AIR CONDITIONING - COCKPIT FOOT WARMER DUCT INSPECTION

This service document provides parts and instructions to inspect the deflector assembly clamps and install as required.

MTL-21-03
Page 1 of 5

Figure 1. Clamp Installation (Sheet 1)

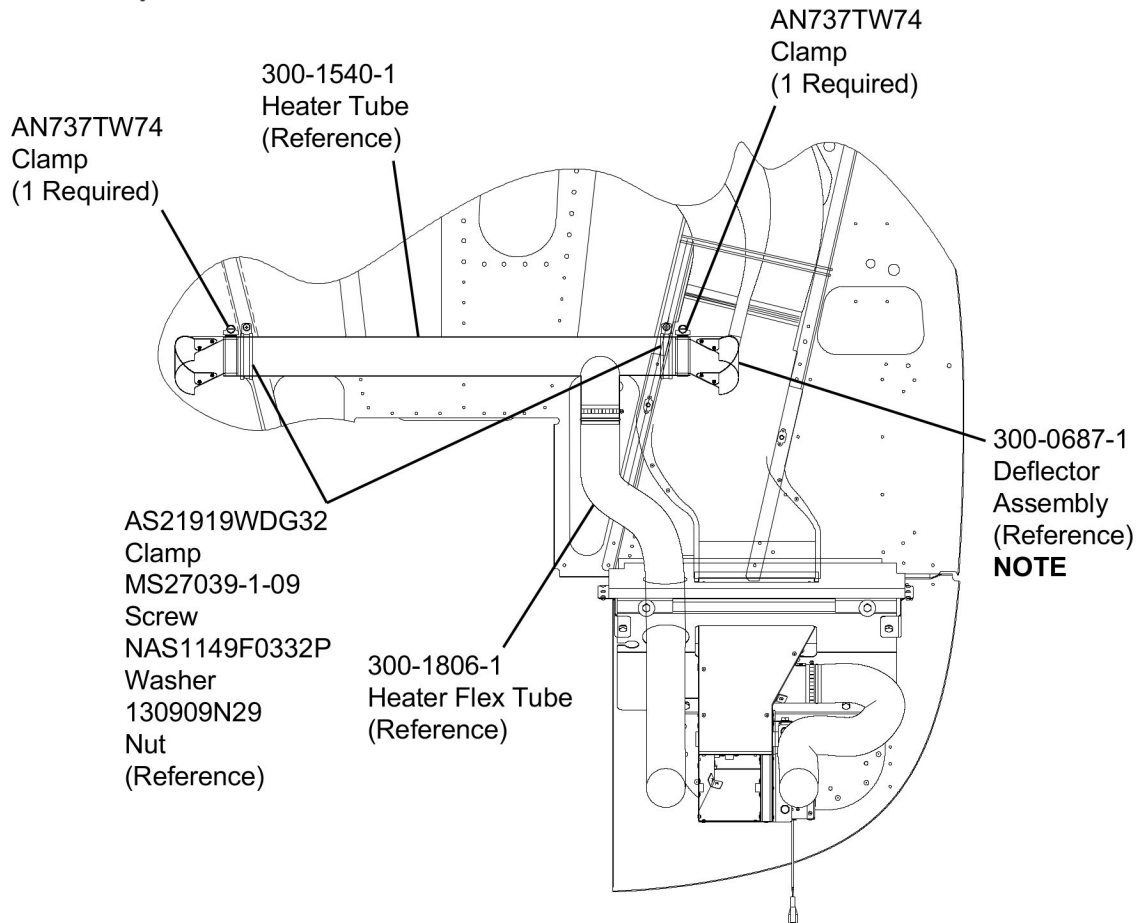
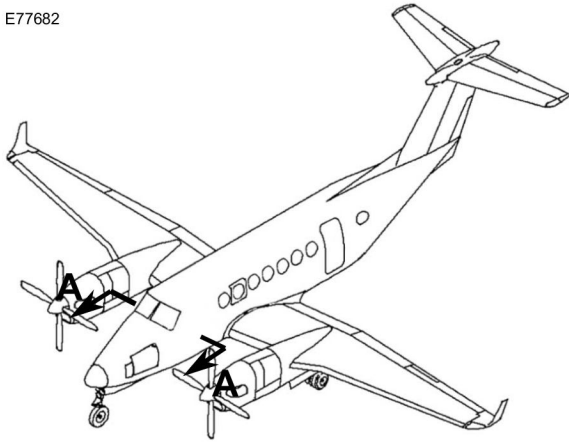
During initial inspection it has been found that the deflector assembly clamps may not have been installed.

2. (Refer to Figure 1, View A-A.) Do an inspection of the heater tube and deflector assembly for the AN737TW74 Clamps installation.
 - A. If the AN737TW74 Clamps are installed in the deflector assembly, then go to Step 5.

- (10) Place one AN737TW74 Clamp onto the left and right side of the 300-1540-1 Heater Tube.
 - (11) Position the 300-0687-1 Deflector Assembly onto the left and right side of the 300-1540-1 Heater Tube, pointed aft approximately 30 degrees down from horizontal.

- (12) Install the AN737TW74 Clamps to secure the two 300-0687-1 Deflector Assemblies onto the 300-1540-1 Heater Tube.
 - (13) Position the 300-1540-1 Heater Tube and tighten the clamp that attach the 300-1540-1 Heater Tube to the 300-1806-1 Heater Flex Tube.

NOTE: Point the 300-0687-1 Deflector Assemblies aft, 30 degrees down from horizontal.
